**TO:** Cameron Mullins, Galloway and Company LLC  
**FROM:** Amber Wood Hicken, Planner I  
**DATE:** 9/16/24  
**SUBJECT:** Parker Pointe AMD1 L3A Car Wash – Site Plan Review Comments 01

**PROPOSED CAR WASH FOR:**

**MISTER CAR WASH (CO 1452 STROH)**

**Project Number: SP24-086**

**Schedule**

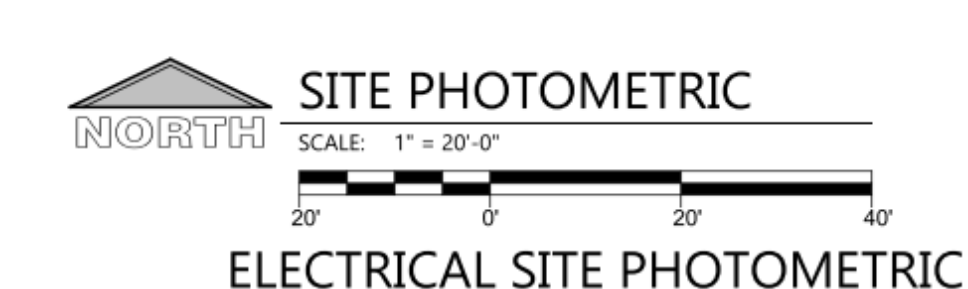
what are these zones? label as parking lot, etc.

Zones have been added/labeled.

**PRE-1**

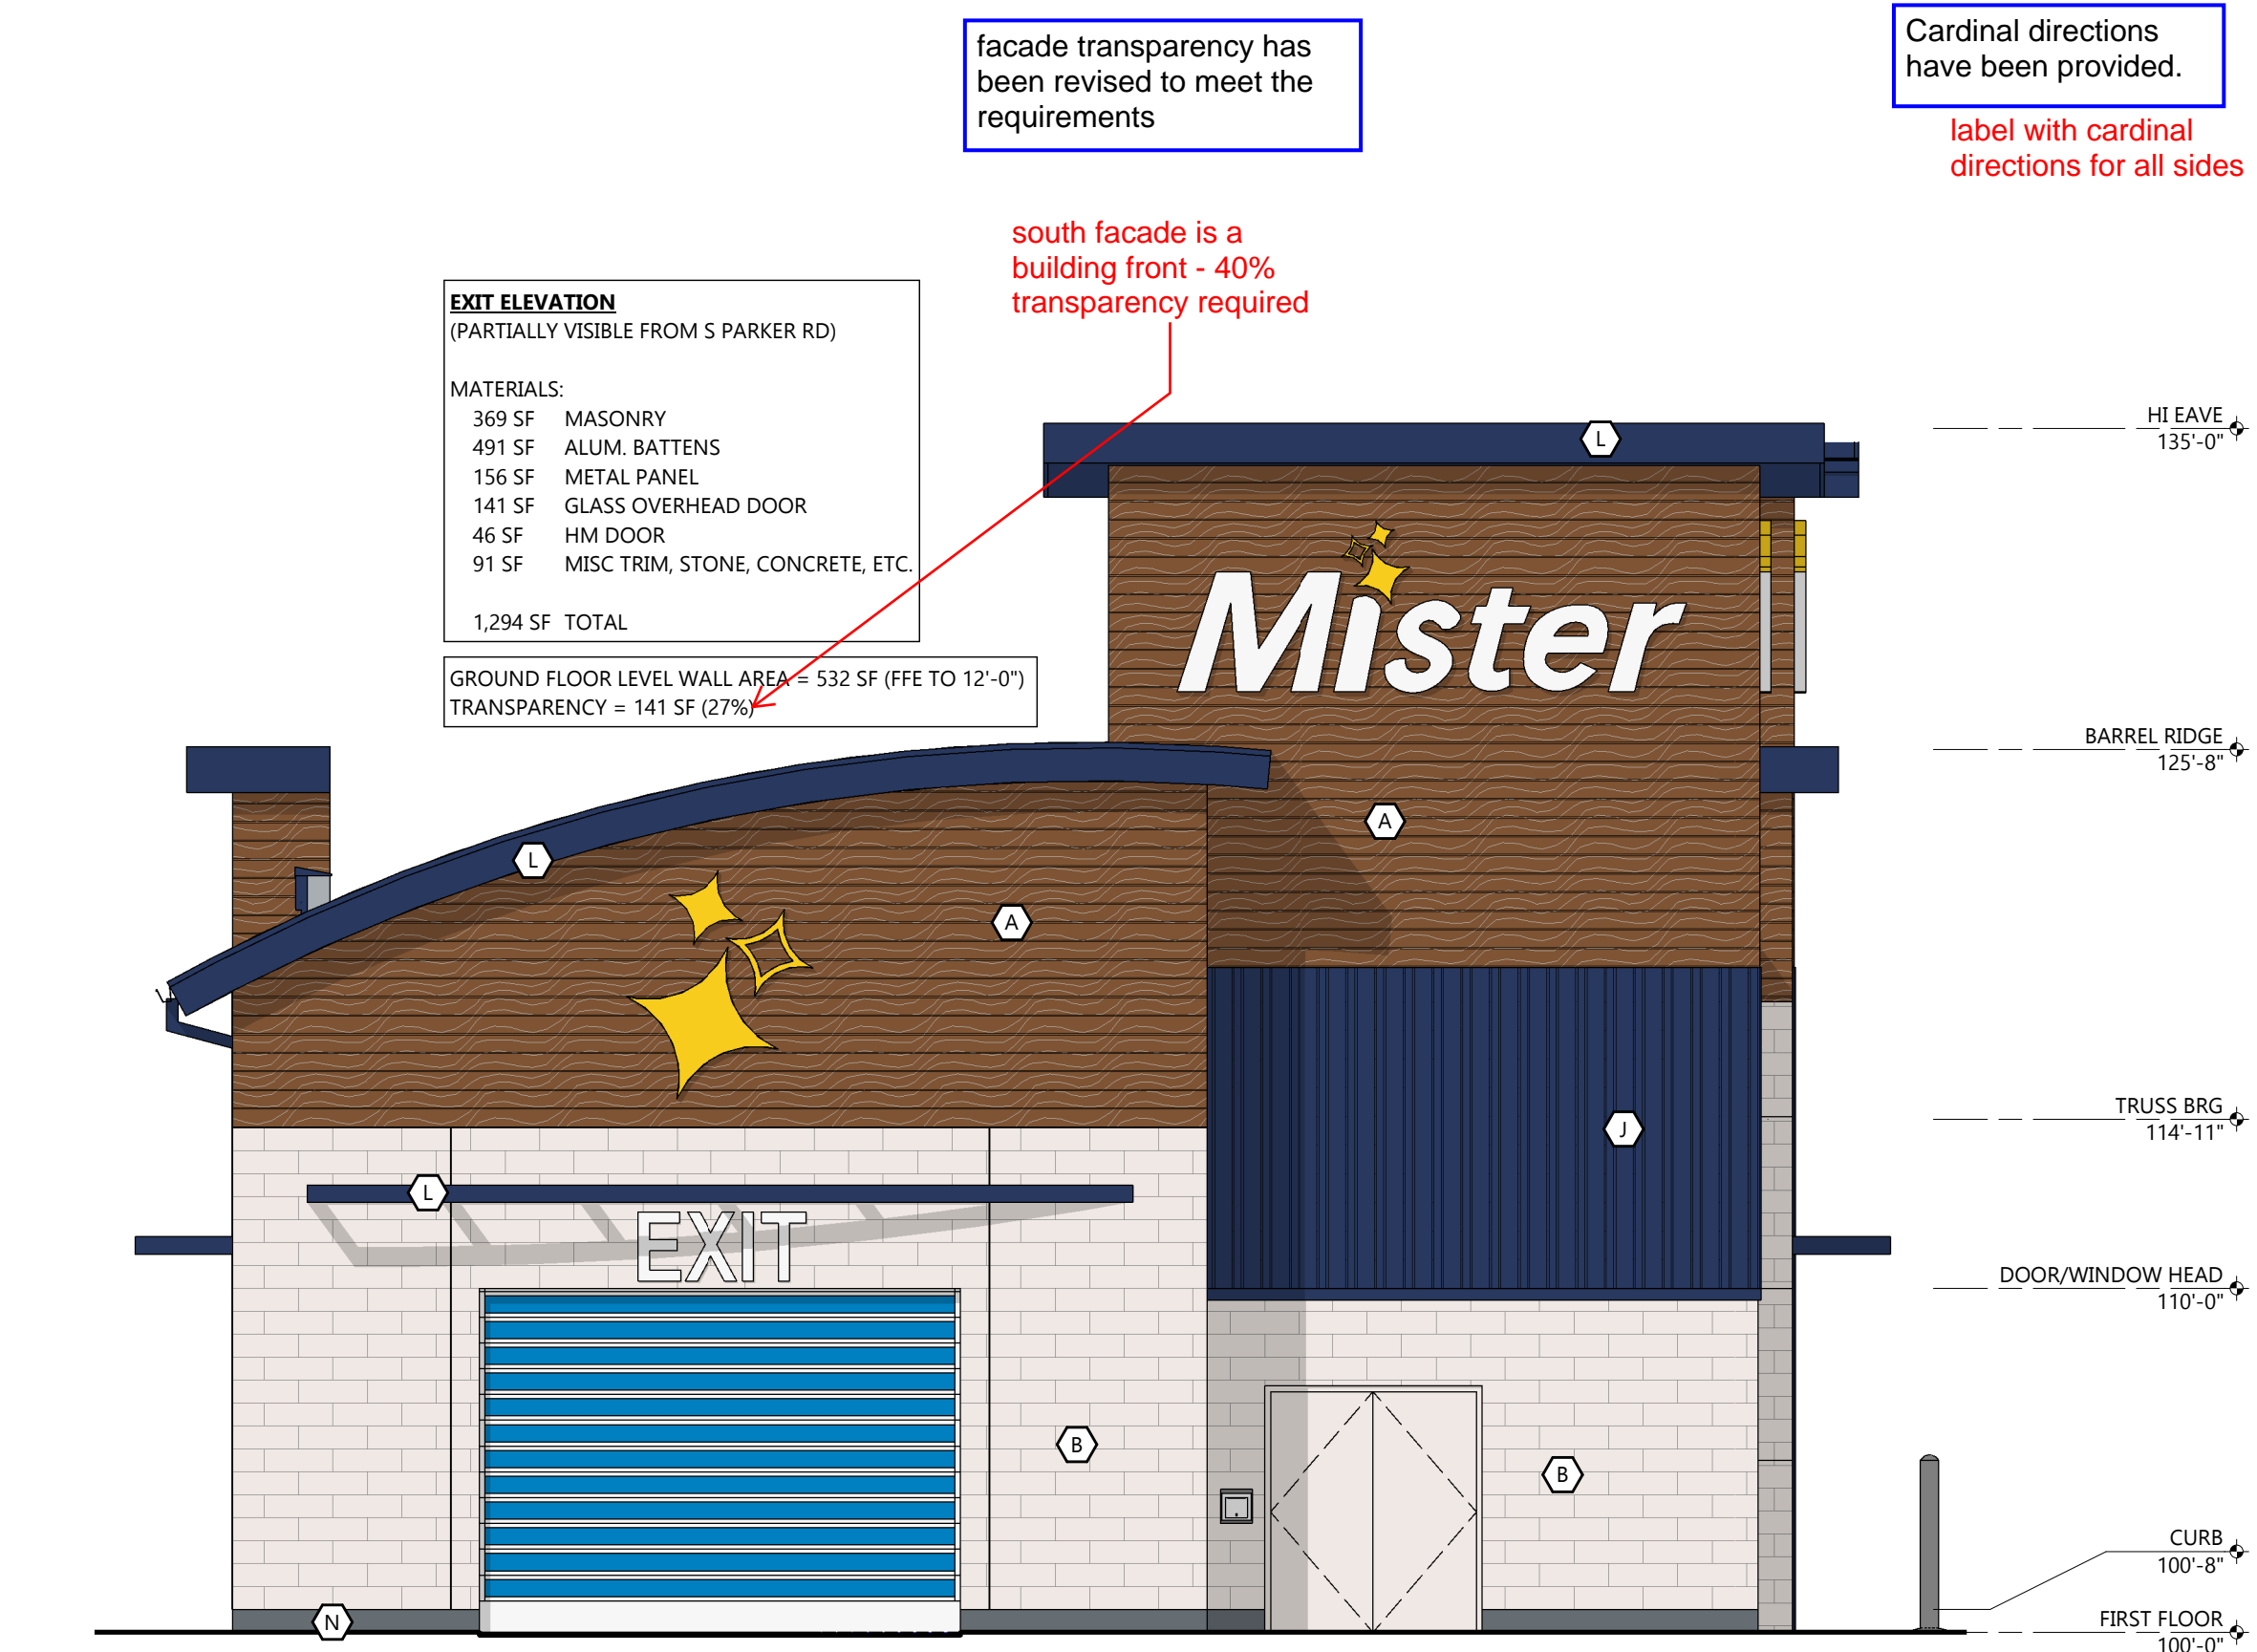
color elevations needed for attendant hut, vacuum enclosure, trash enclosure

spec sheet needed for vacuums, ball out lane gate, bollards (materials, colors, heights)

colored elevations have been added to this set for the requested items

Plans have been added for the requested items

**OFFICE ELEVATION**  
SCALE: 3/16" = 1'-0"

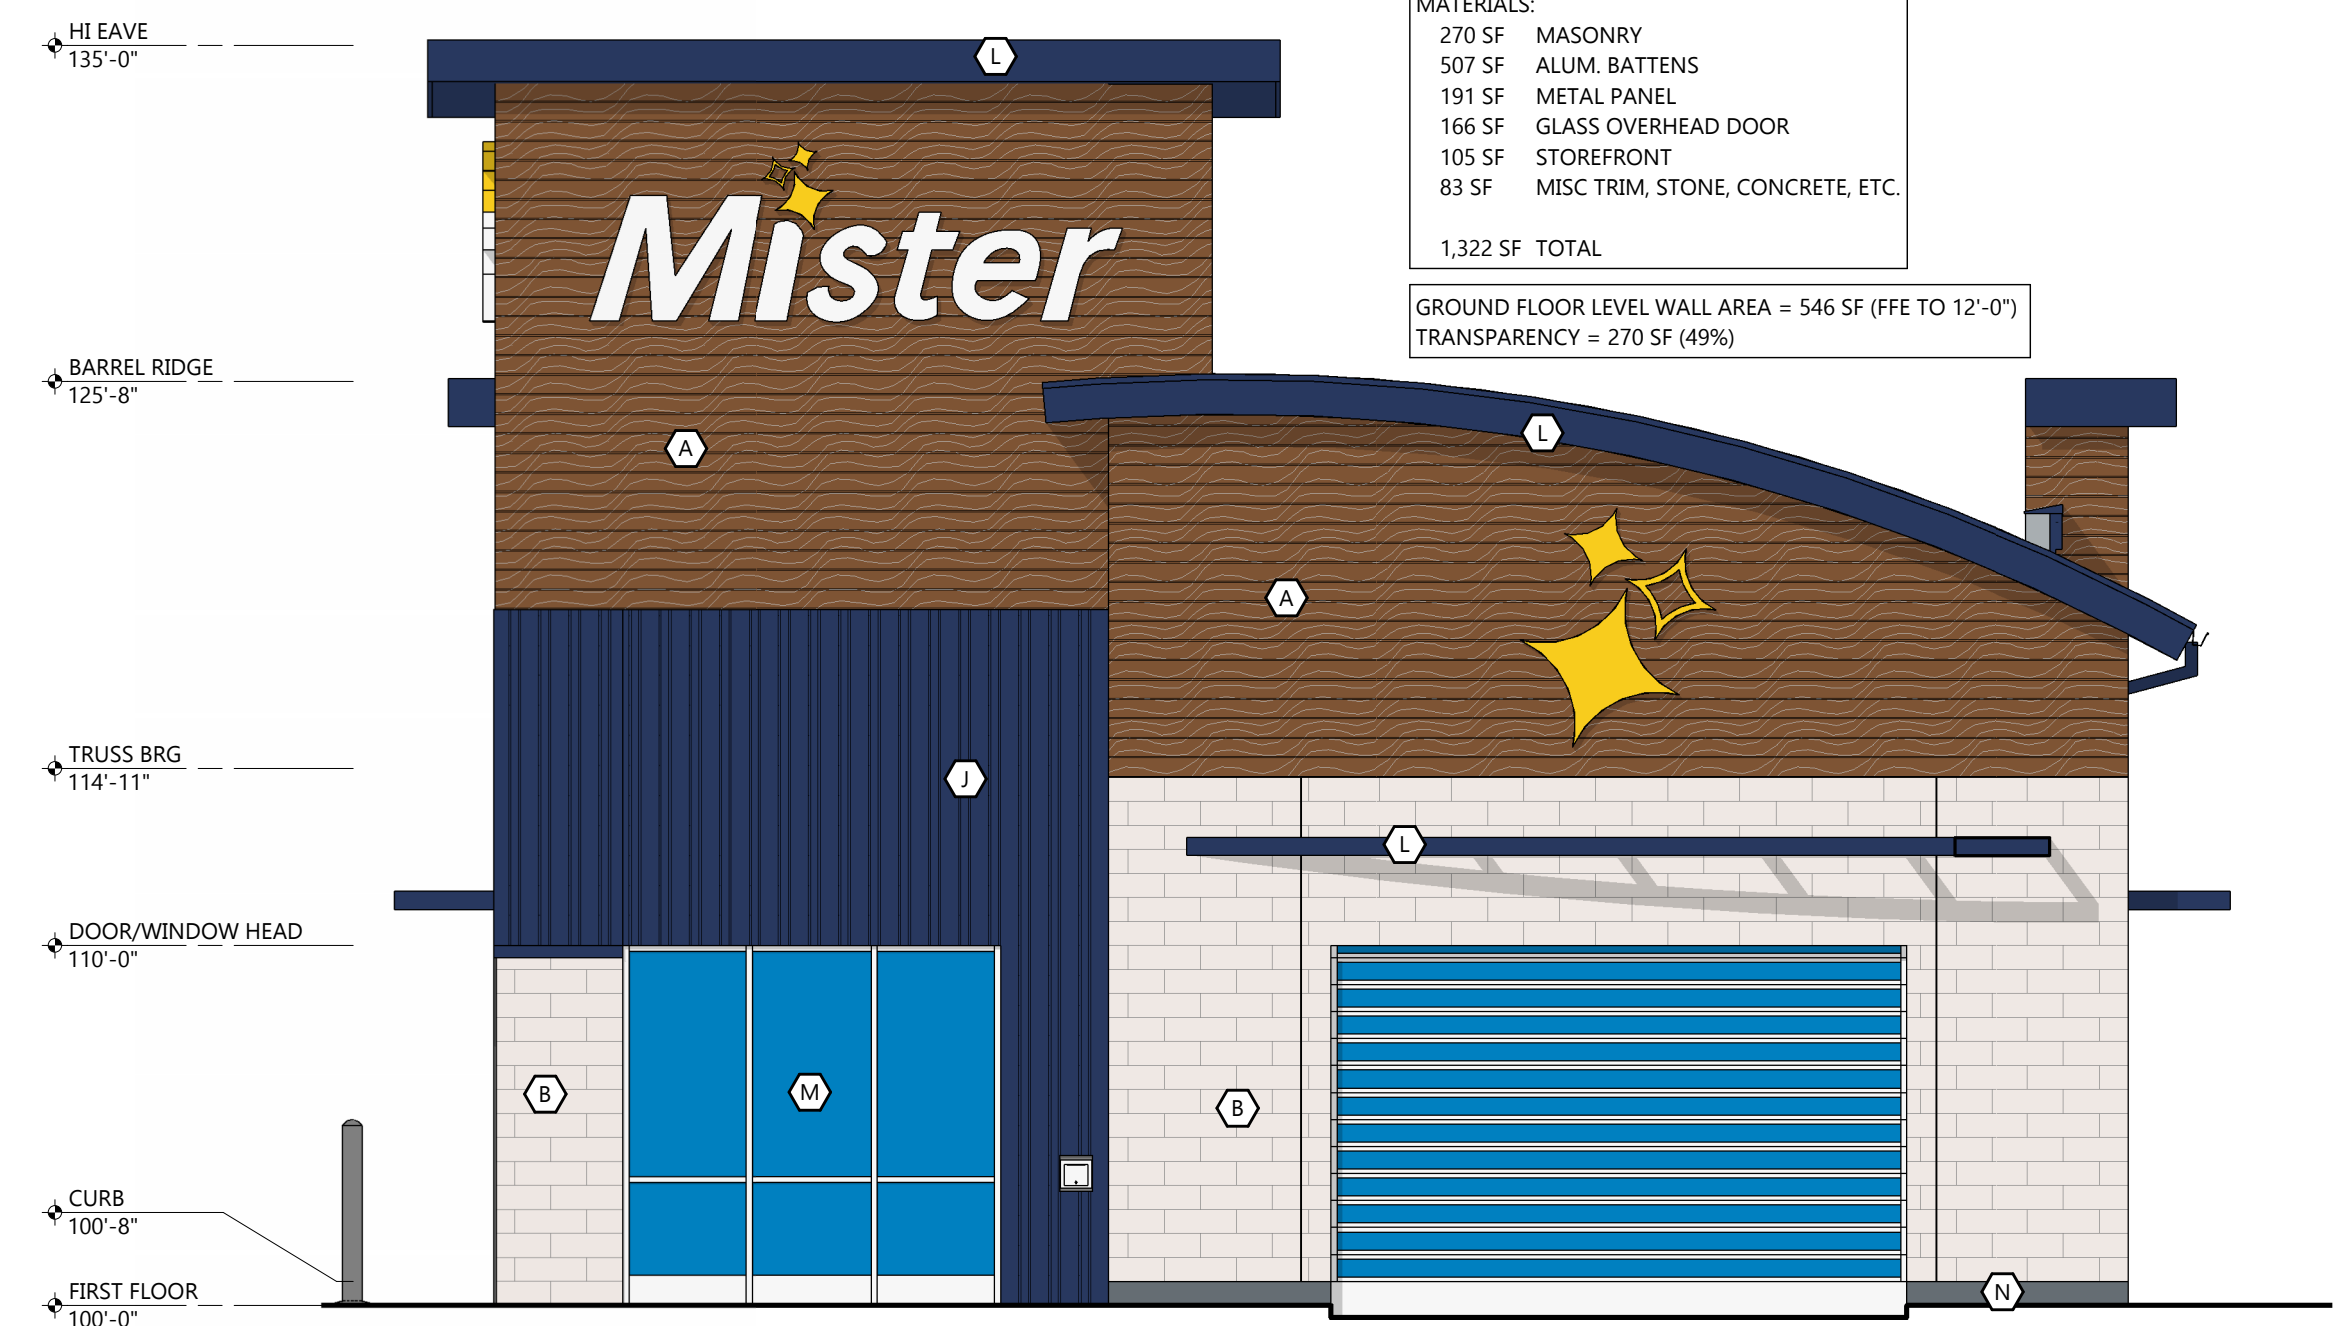
south facade is a building front - 40% transparency required

Cardinal directions have been provided.  
label with cardinal directions for all sides

facade transparency has been revised to meet the requirements

**TUNNEL ELEVATION**  
SCALE: 3/16" = 1'-0"

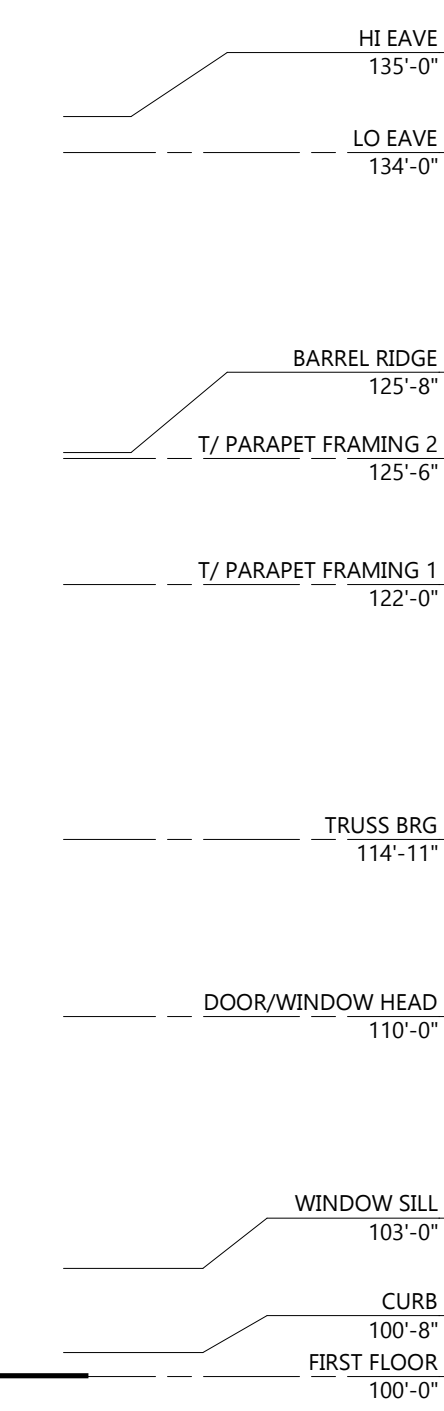
west facade is a building front - 40% transparency required

facade transparency has been revised to meet the requirements
